LEGAL DESCRIPTION:

TRACTS A-1 AND A-2 LAND OF DAVID MACIEL

ENGINEER'S SEAL	MONTOKA STREET TOWNHOMES	DRAWN BY WCMJ
	DAVID SOULE	GRADING AND DRAINAGE PLAN	DATE 10-15-15
	10/15/15		21523-LAYOUT-8-05-15
DAVID SOULE P.E. #14522		1806 CENTRAL AVENUE SE SUITE 201 ALBUQUERQUE, NM 87106 (505) 872-0999	SHEET # JOB # 21523

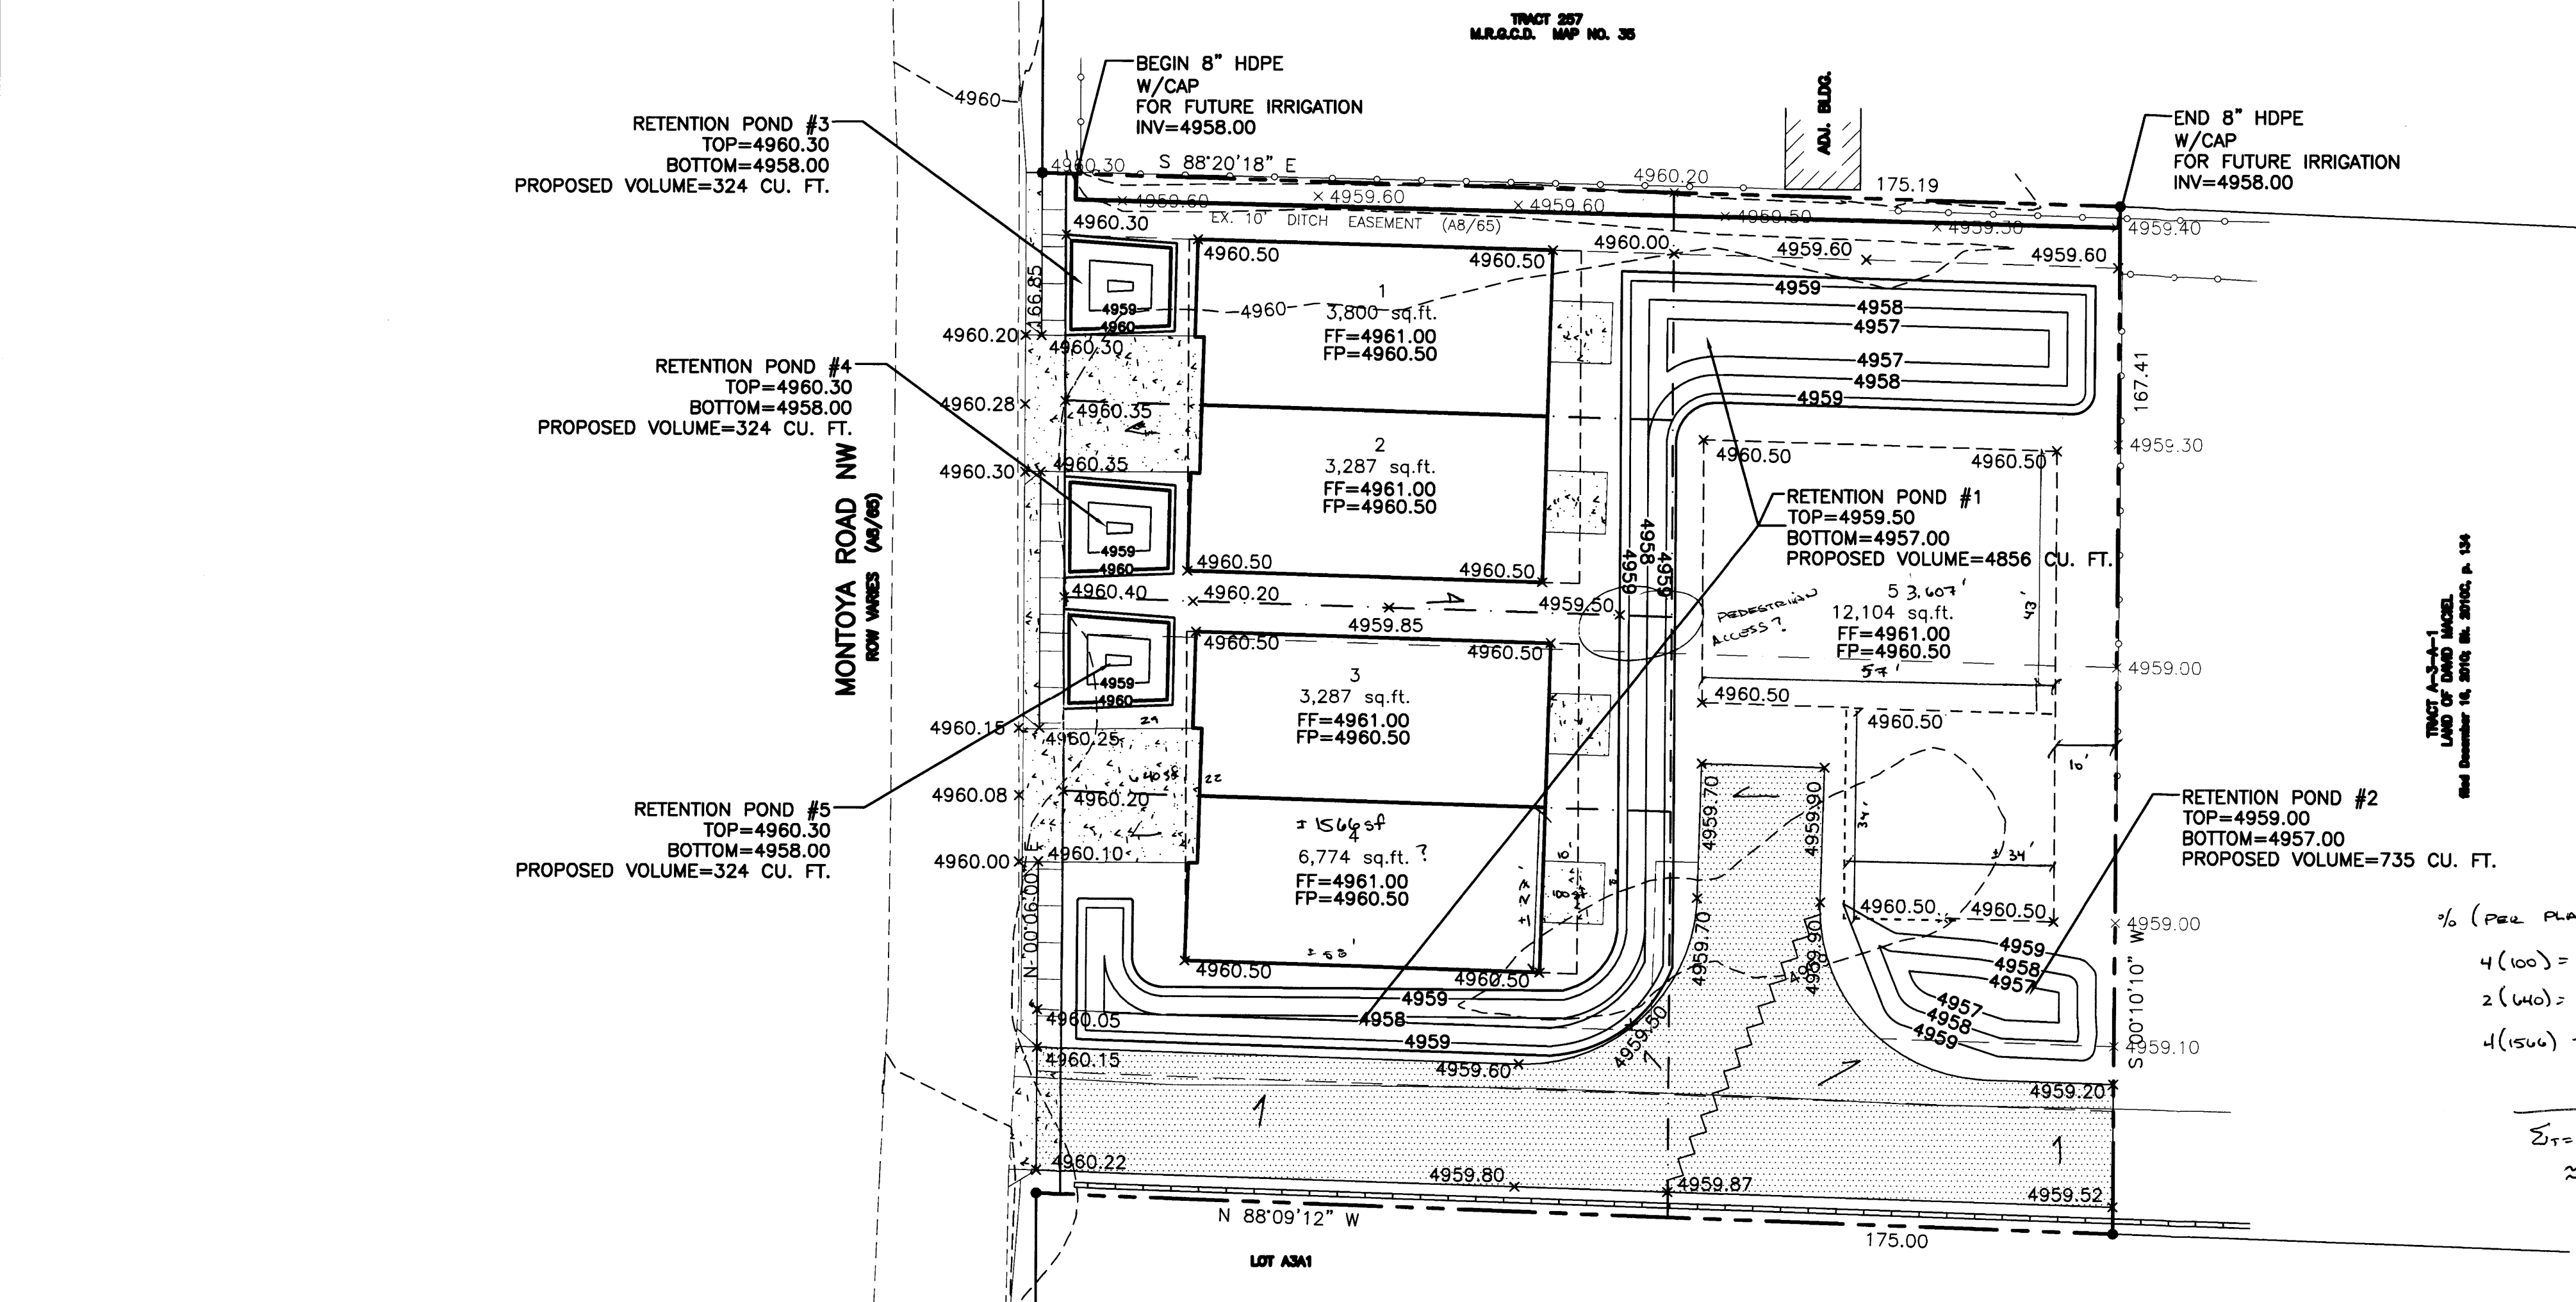
- PROVIDE FLOW ARROWS FOR OVERALL DRAINAGE SCHEME
- PROVIDE ROOF DRAINAGE LOCATIONS
- CLEARLY DEFINE PROPERTY LINES
- EXIST 10' DITCH EASEMENT LIMITS
- DOS THE PLATIN ACTION COMBINE LOTS A1 & A2?
- DRAINAGE REPORT INDICATES AN EVENT EXCEEDING THE 100-YR STORM EVENT, DRAINAGE WILL FLOW TO MONTOYA ROAD. WITH SPOT ELEVATIONS SHOWN, IT APPEARS FLOWS WILL TRAVEL FIRST AWAY FROM MONTOYA.
- SHOW FLOWS FOR CROSS LOT DRAINAGE, WHICH PROPERTIES ARE EXPECTED TO FLOW ON SITE?
